ALL DEPARTMENTS REVIEW COMMENTS (First Submittal/Design V1)

Staff recommends Patio Home Preliminary Plat approval subject to all concerns and comments listed under the “ALL DEPARTMENTS REVIEW COMMENTS” section of this staff report being addressed and the development meeting all applicable development codes required to gain final plat approval.

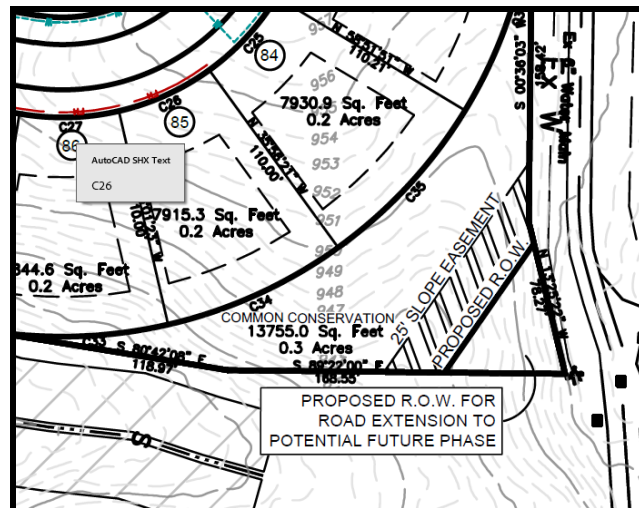
- The proposed 25' ROW on the southeast corner of the property must be a minimum of 50' if the intent is to use it as access for a future expansion. Changing this will reduce the square footage of the common conservation area so this will need to be updated as well. See image below.
